IMPORTANT SAFETY RECALL

NHTSA Recall No. 15V-781

Strick Trailers, LLC ("Strick Trailers") has decided that certain 28 ft. dry freight van trailers, model number S4280E99NFWO, as identified on the enclosed spreadsheet, fail to conform to Federal Motor Vehicle Safety Standard No. 223 "Rear Impact Guards".

STRICK TRAILERS, LLC #705703 / REAR IMPACT GUARD FIELD RETROFIT INSTRUCTIONS:

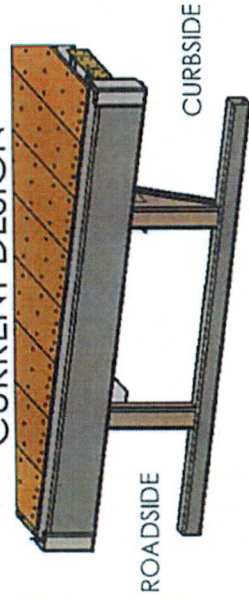
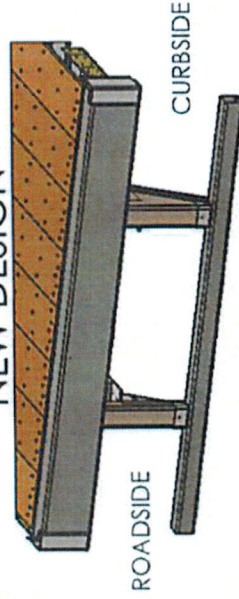
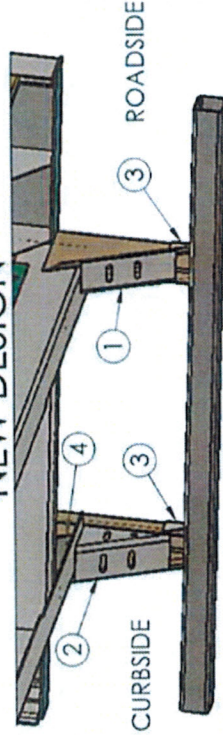
The noncompliance is in regards to the curbside and roadside rear impact guard gussets. Strick Trailers identifies the gussets with the numbers 46829 and 46830. These gussets do not meet the requirements of Federal Motor Vehicle Safety Standard 223 pertaining to rear impact guards. This could increase the risk of injury in the event of a rear impact crash.

CURRENT DESIGN

NEW DESIGN

In order to remedy the noncompliance, it will be necessary to reinforce the curbside and roadside rear impact guard gussets in accordance with the instructions (Drawing 705703) attached to this letter. We will supply the new reinforcement parts without cost and will ship them to multiple locations at your request. The parts necessary to reinforce the gussets are expected to be available for delivery beginning on February 2, 2016. We will also reimburse you for the reasonable direct labor costs involved in effecting the repair or will have the repair facilities bill us directly. The work to reinforce the rear impact guard gussets will take approximately two and one half hours to perform.

3. PREPARE ALL SURFACES TO BE WELDED INCLUDING EXISTING AND NEW BY EXPOSING THE BARE METAL AT THE LOCATION OF THE WELD.
4. POSITION AND WELD ITEM ① AS SHOWN ON SHEET 2.

5. POSITION AND WELD ITEM ② AS SHOWN ON SHEET 2.
6. POSITION AND WELD ITEM ③ ON THE ROADSIDE AND CURBSIDE GUSSET AS SHOWN ON SHEET 2.
7. POSITION AND WELD ITEM ④ IN THE ROADSIDE AND CURBSIDE SUBFRAME CHANNEL AS SHOWN ON SHEET 2.
